From: pak yeung Yung [REDACTED]
Sent: Tuesday, November 4, 2025 3:03 PM
To: tpbpd/PLAND <tpbpd@pland.gov.hk>; TPB Submission/PLAND <tpbsubmission@pland.gov.hk>
Cc: [REDACTED]
Subject: Application No. A/NE-PK/219 - Submission of Further Information

R to C Table

Formation/
 Drainage Plan
PLAN 3B

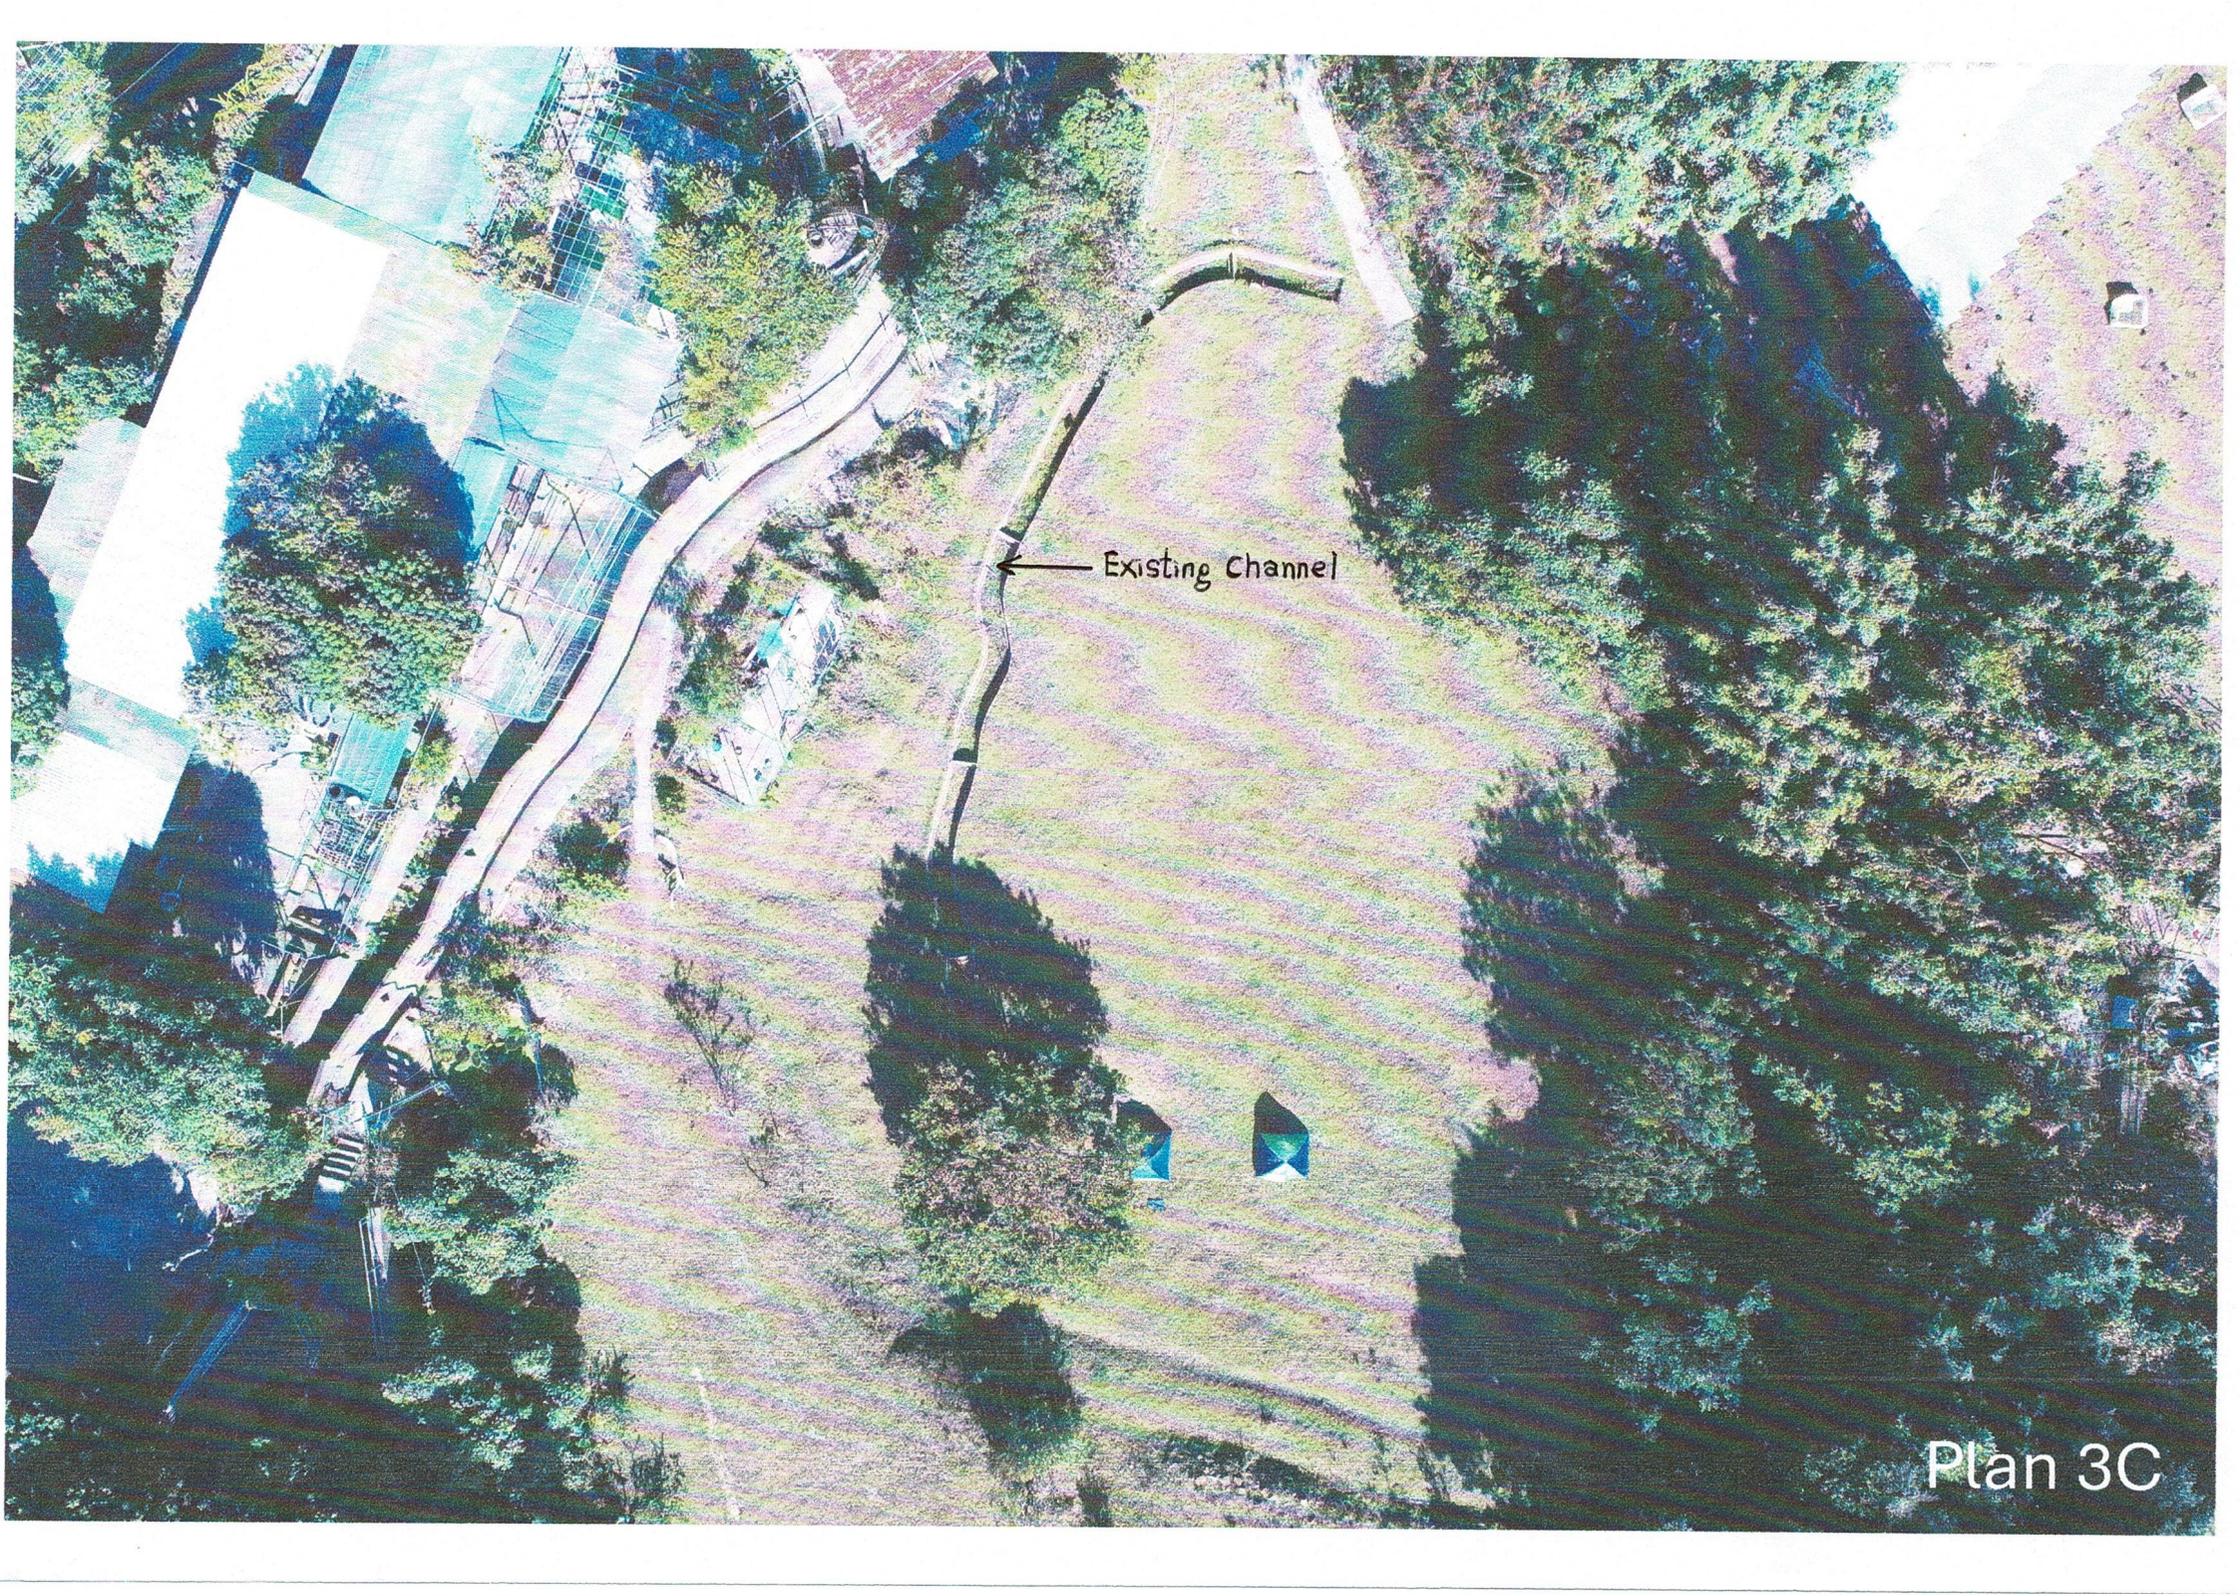
(a) a topographic survey plan that supports the fall direction indicated on the drainage layout plan;	Noted. Please see Plan 3B . the farming area is relatively flat with gradients between 1:25 and 1:100

(b) a layout showing the proposed formation level of the proposed hard paved area to demonstrate that the proposed fall direction would be achieved; and	Noted. Please see Plan 3B ¹ .

(k) peripheral U-channels with Cast-Iron grated cover with levels matching the adjacent ground to intercept any surface runoff flowing across the lot boundary should be provided. The applicant is required to review their submission to provide adequate peripheral channels; and	Noted. Please see Plan 3B . Details of peripheral U-channels would be provided in the formal submission of drainage proposal upon approval of the planning application.

Plan 3C

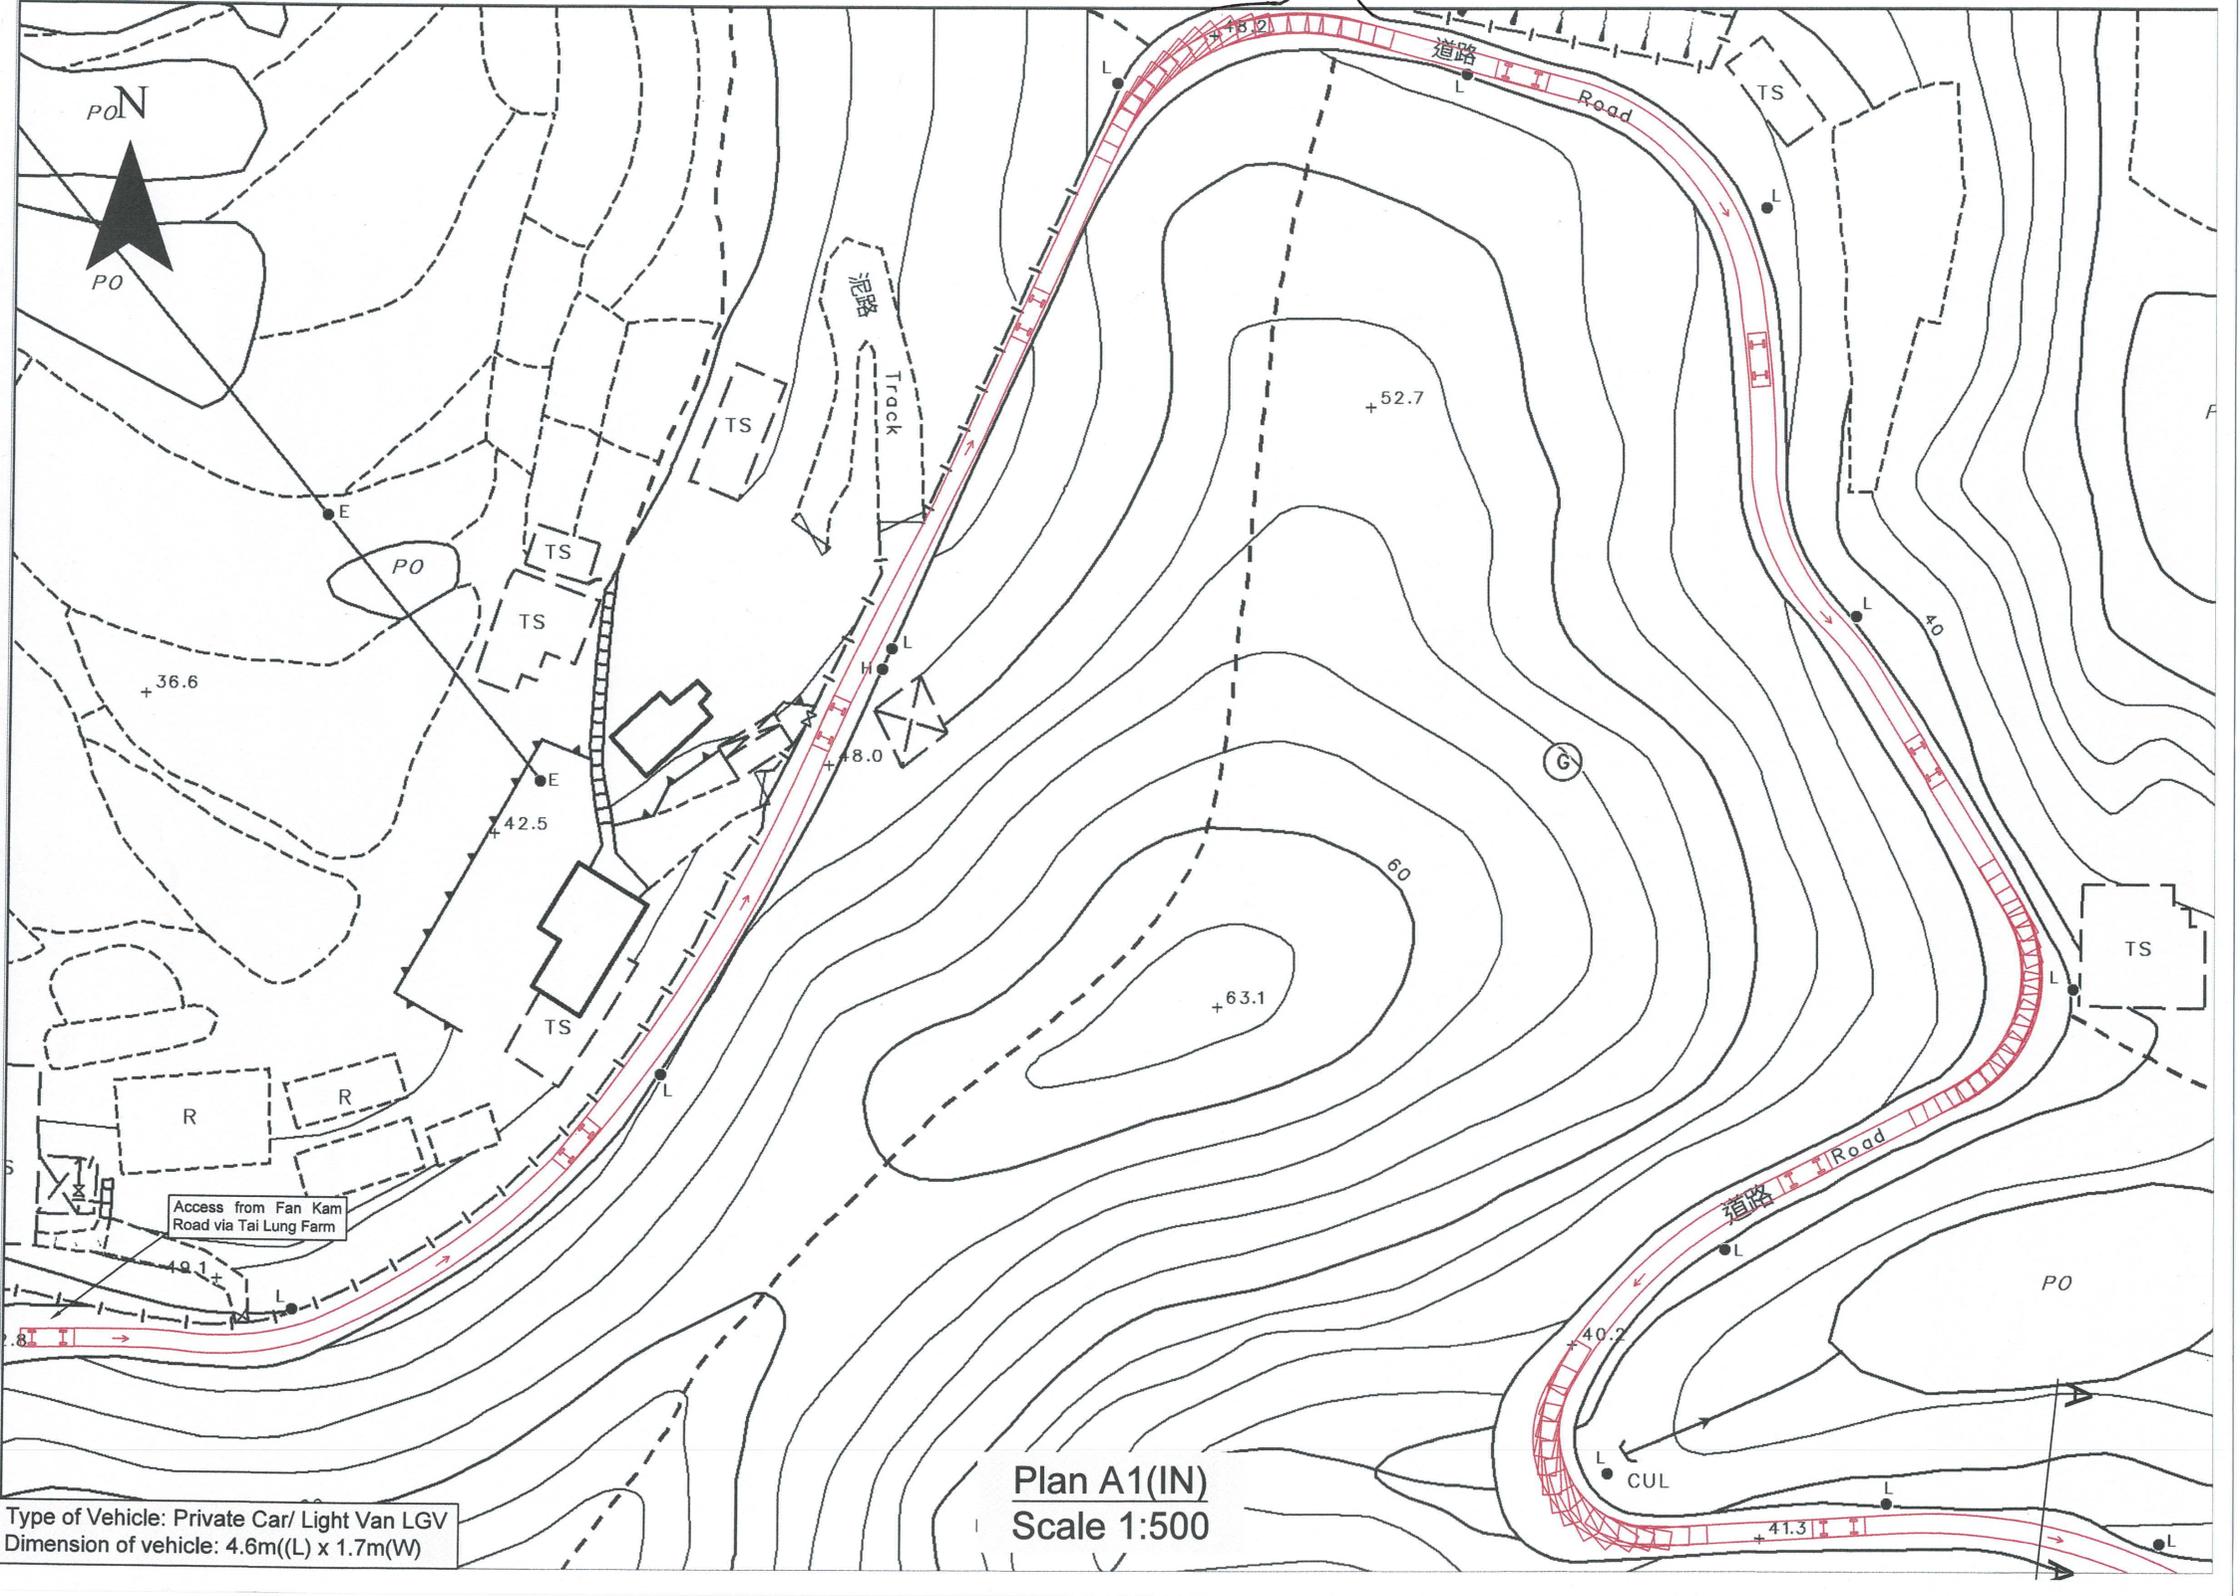
(c) a set of record photos should be provided showing that the existing open channel is cleared.	Noted. Please see Plan 3C
(ii)	General comments regarding the drainage aspect:

Plan A1(IN)
Scale 1:500

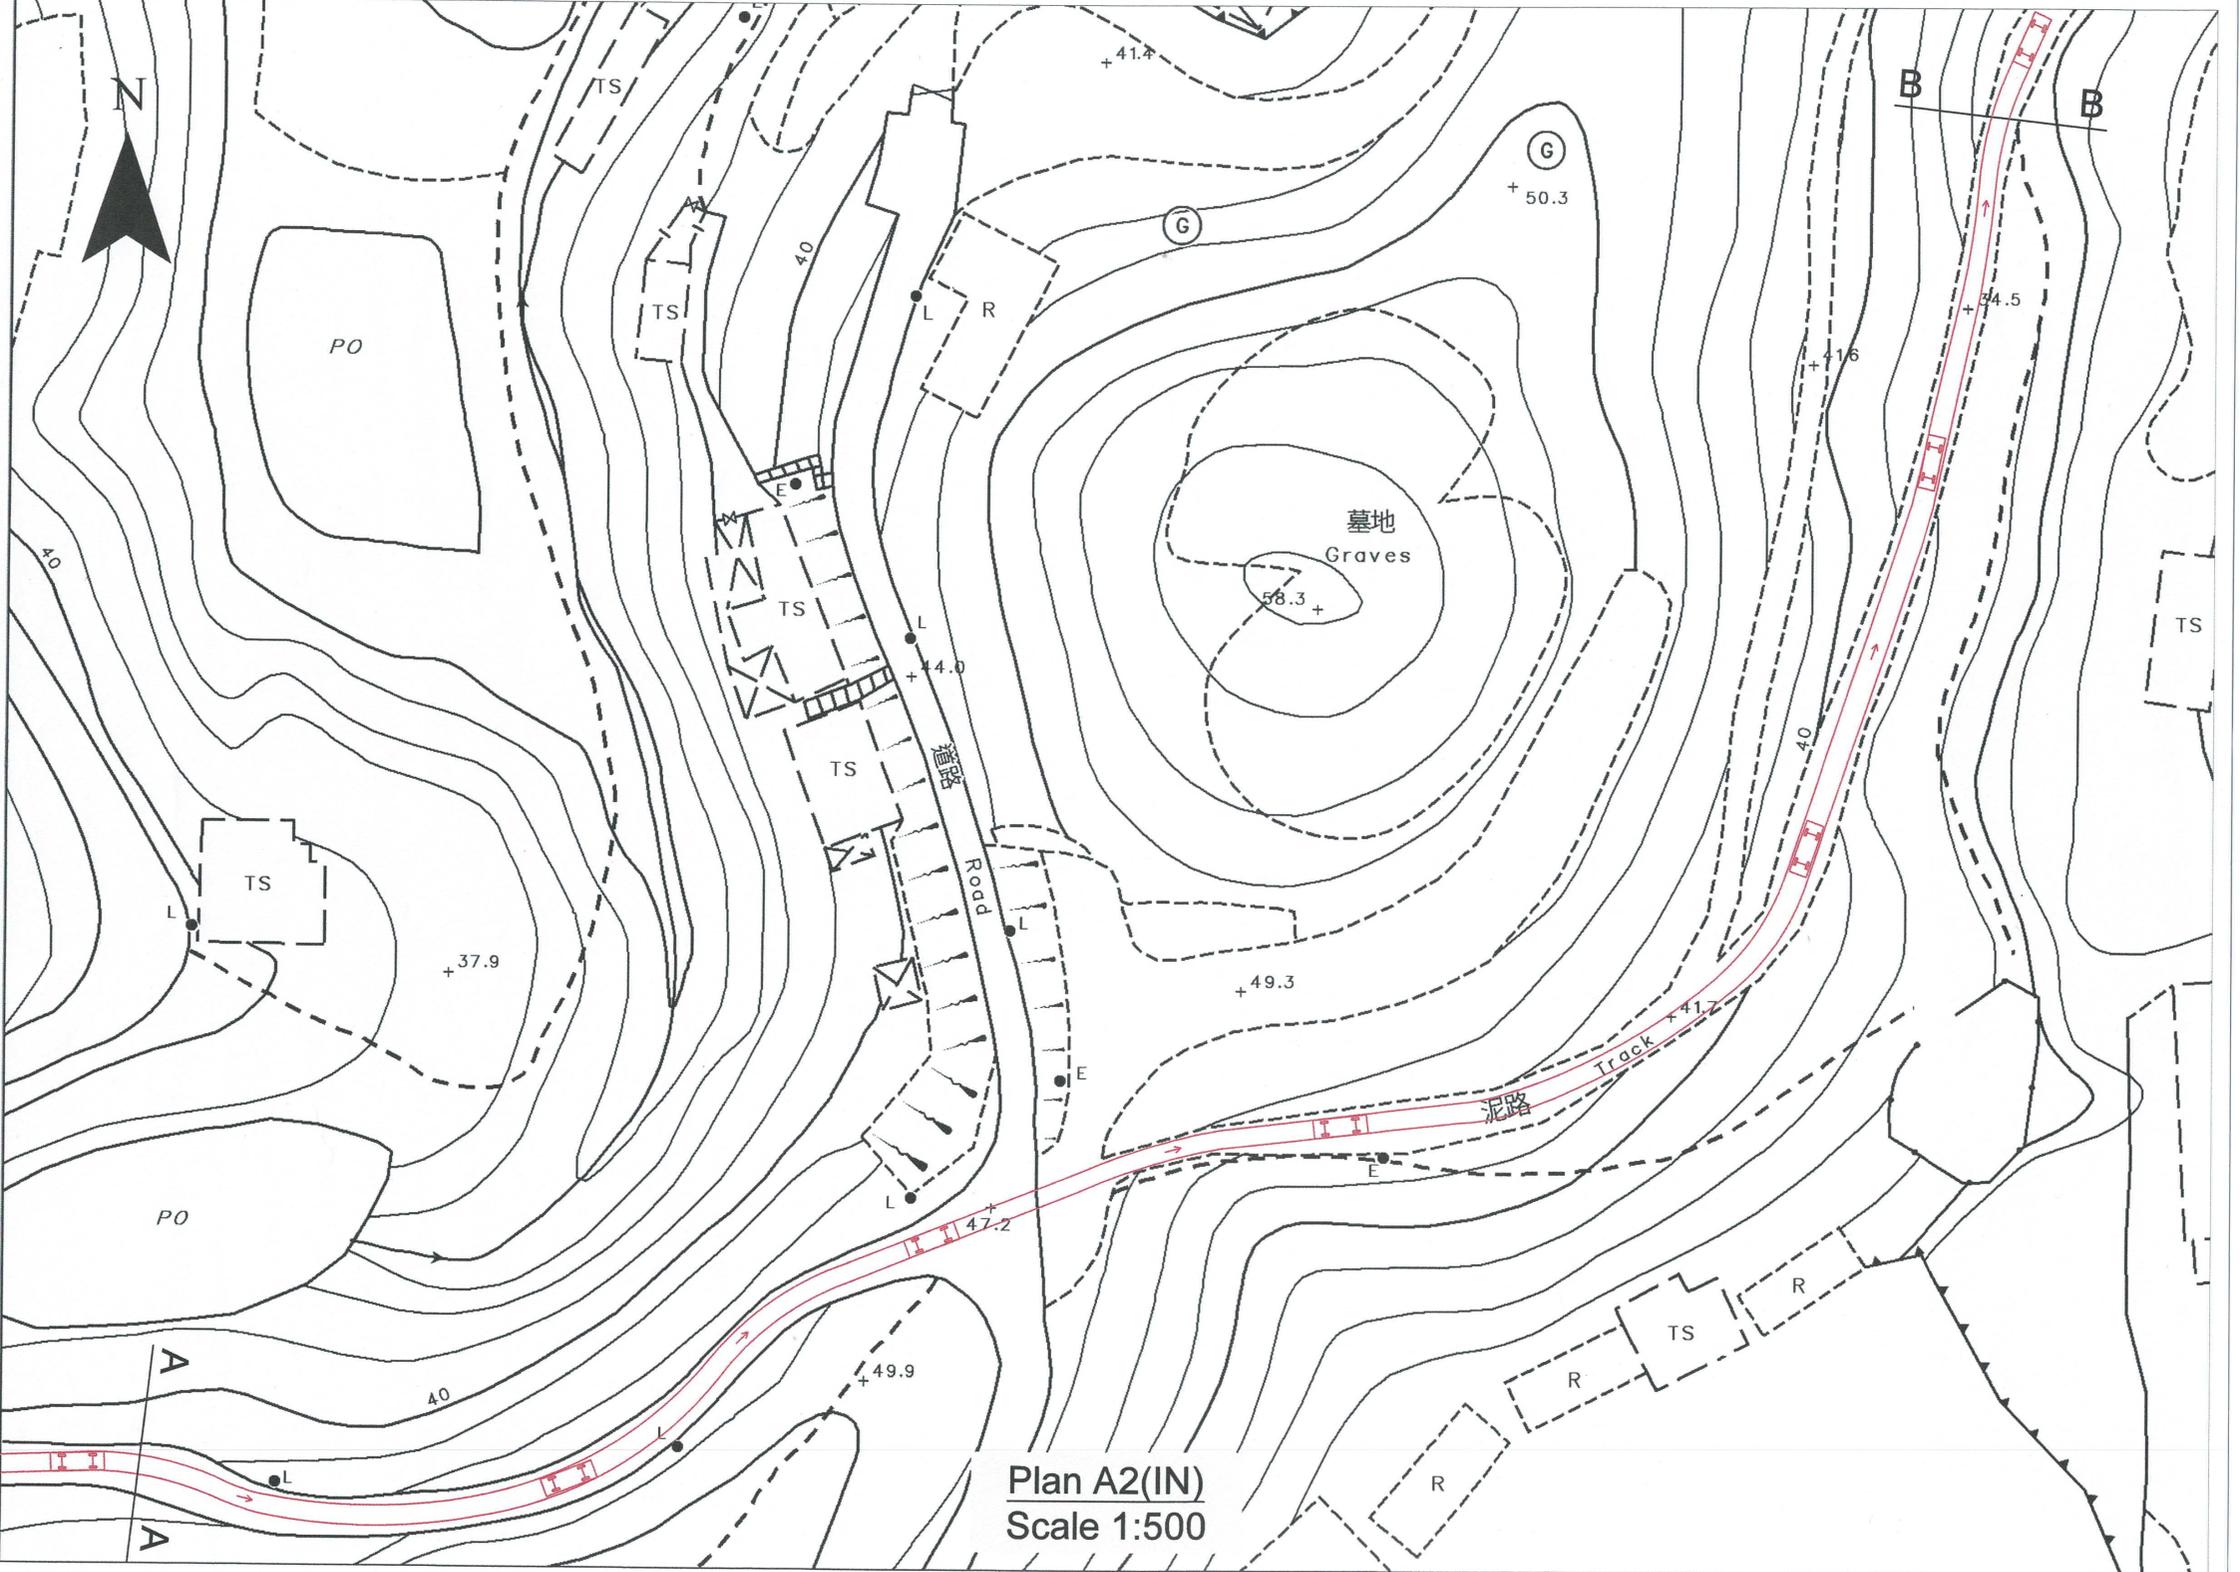
3. Comments of C for T, TD		
(i)	The applicant shall provide a swept path analysis for vehicles manoeuvring into and out of the subject site;	Noted. Please see Plans A1 to A3 and B1 to B3.
(ii)	Noted that advanced booking is required for the visit to the subject site. Please clarify whether there will be a gate installed at the entry. If so, please ensure such arrangement will not cause queuing of vehicles outside the subject site;	Noted. A gate would be installed at the entry. The parking and L/UL facilities would only be opened to visitors with prior appointment. Their time of arrival would be properly regulated so that no simultaneous entry of vehicles would occur.
(iii)	The applicant shall advise the provision and management of pedestrian facilities to ensure pedestrian safety; and	The hard paved area and the field paths/furrows of the farming/ planting areas can serve as pedestrian walkway. Visitors would need to report to the farm office upon arrival and leave. Staff would then guide and manage pedestrian movement to ensure no conflict of pedestrian and vehicular traffic.
